CSM IMPROVEMENT WORK PLAN

ROUTE 8 LANDFILL & BCO HILL
SIDNEY, NEW YORK

NYSDEC ROUTE 8 LANDFILL & BCO HILL
SITE NO.'S 413009 & 413003
SIDNEY, DELAWARE COUNTY
CONCEPTUAL SITE MODEL IMPROVEMENT WORK PLAN APPROVAL WITH
MODIFICATIONS
DATED JULY 7, 2021

RE: Route 8 Landfill & BCO Hill (Site No.'s 413009 & 413003), Sidney, Delaware County
Conceptual Site Model Improvement Work Plan Approval With Modifications

Figure 6A
Route 8 and Hill Site
Proposed Pre-shutdown
Groundwater Sampling Locations
Amphenol Corporation
Sidney, New York

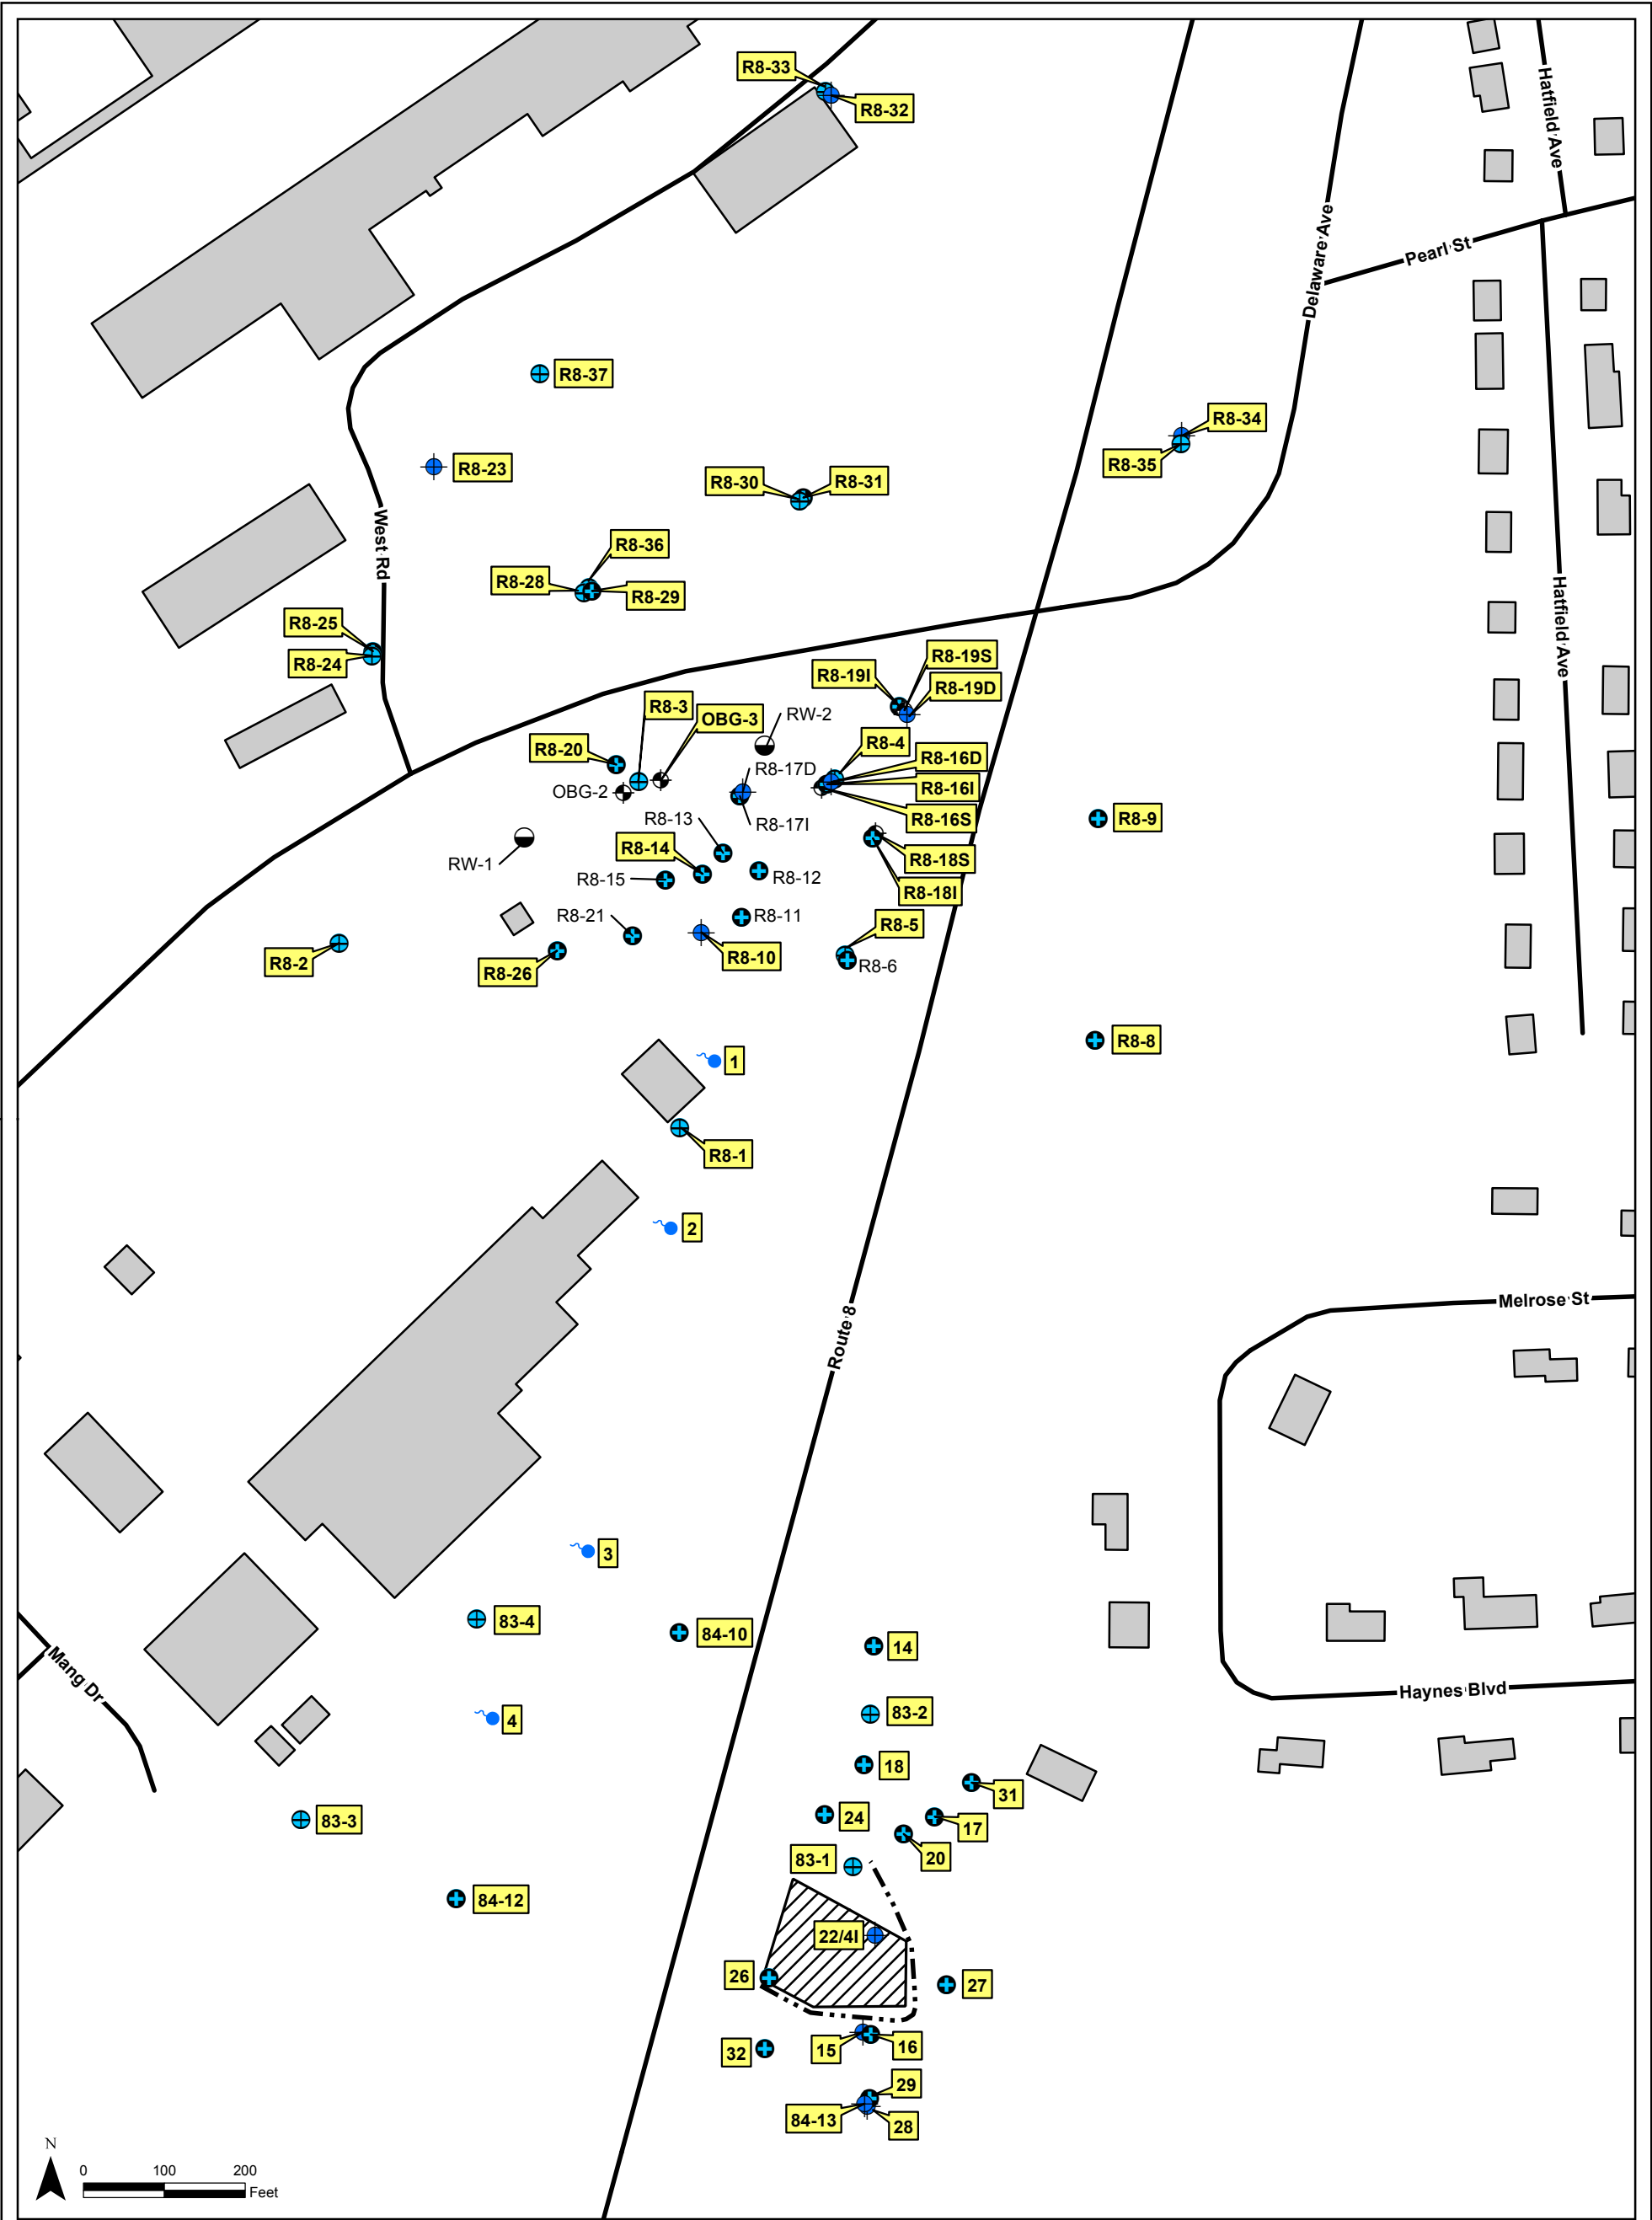
1. Please correct/clarify in the last paragraph on page 7 (page 10 of the pdf) that eight wells (not seven) will be geophysically logged.
2. Figure 6 needs to be updated to reflect recent changes to the work plan text. Please break this into two figures, as follows:

- a. Figure 6A: Identify the wells sampled quarterly during the shutdown and those sampled every fifth quarter under routine monitoring.
 - b. Figure 6B: Identify the wells selected for geophysical monitoring.
